HISTORIC AND DESIGN REVIEW COMMISSION

June 07, 2017

HDRC CASE NO: 2017-262
ADDRESS: 301 BARRERA
LEGAL DESCRIPTION: NCB 714 BLK 11 LOT S 80.9 FT OF 1
ZONING: RM-4 H
CITY COUNCIL DIST.: 1
DISTRICT: Lavaca Historic District
APPLICANT: Lewis Fisher/Fisher Heck Architects
OWNER: Christine Becksted
TYPE OF WORK: New fencing, new handrail, hardscape modifications, alterations to front steps

EAST EXTERIOR ELEVATIONS | 05/12/2017

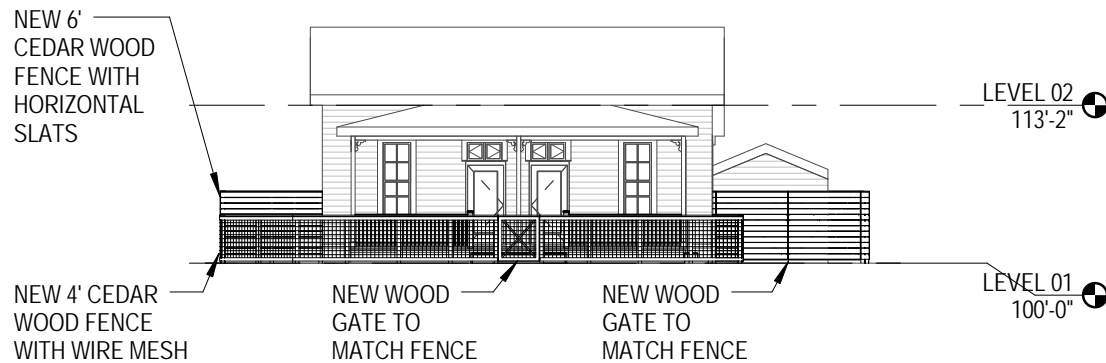
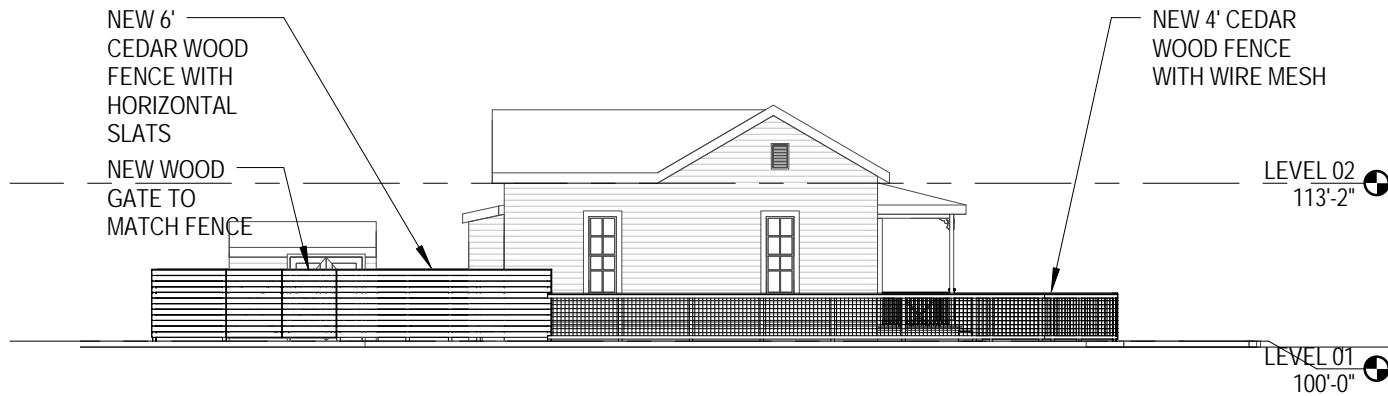
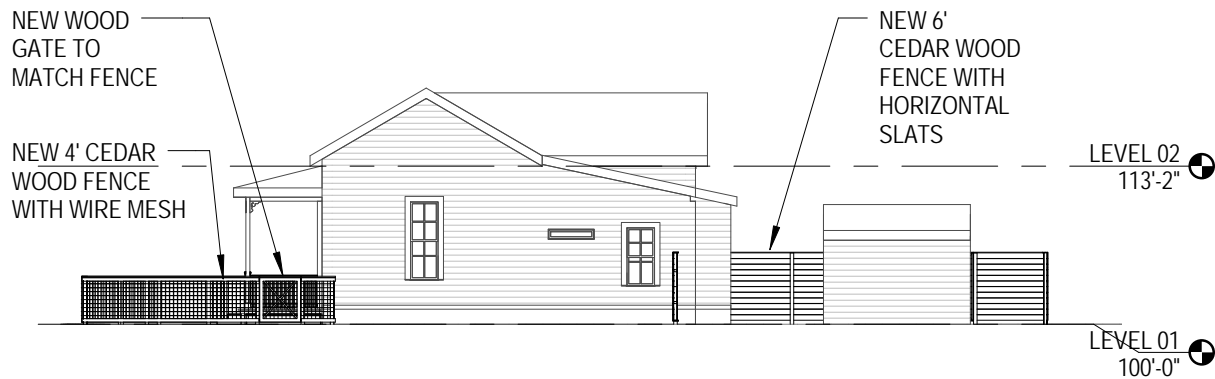
- f. **NEW HANDRAIL** – The applicant has proposed to install a new handrail on the front porch. Based on the submitted narrative and elevations, the handrail will be made of wooden newel posts that frame the front entry, simple square balustrades, and a flat top rail. The handrail will utilize the existing wood columns as integral posts in its design. All handrail elements will be painted white to match the existing columns and the trim on the home. According to the Historic Design Guidelines for Exterior Maintenance and Alterations 7.B.iv, added porch elements should be simple as to not distract from the historic character of the building. New elements should not be designed in a way that conveys a false sense of historic appearance. Porch railings are not common historic elements for Folk Victorian homes of this configuration, which feature a porch that sits very low to the ground. The columns of this particular home, which are character defining elements, are very thin and delicate, and staff has not yet received detailed elevation drawings or plans that indicate the height of the proposed railing or the dimensions of the balustrades, newels, and rails, or information on how the proposed railing will interact with the existing columns in terms of structure. Staff does not find the proposal consistent with the guidelines.

- g. **FRONT PORCH STEPS** – The applicant has proposed to modify the existing front porch steps and install new steps on the east side of the porch for driveway access. Both sets of steps will be wooden and painted to match the color of the existing wooden porch decking. The new steps on the east will measure the length from the front façade to the existing porch column. The modified steps on the front will be on center with the main façade and measure the span of the two existing doorways. Currently, the existing front steps are on center with the left door and do not line up with the existing walkway or sidewalk approach. According to guideline 7.B.iv for Exterior Maintenance and Alterations, added porch elements, such as stairs, should be simple as to not distract from the historic character of the building. The proposed stairs on both the front and east sides of the porch are compatible with the style and materiality of the home. Staff finds the proposal consistent with the guidelines.

Item 3, Staff does not recommend approval of the porch railing installation based on finding f.

Item 4, Staff recommends approval of the modification of the existing front porch steps and the addition of new side porch steps based on finding g.
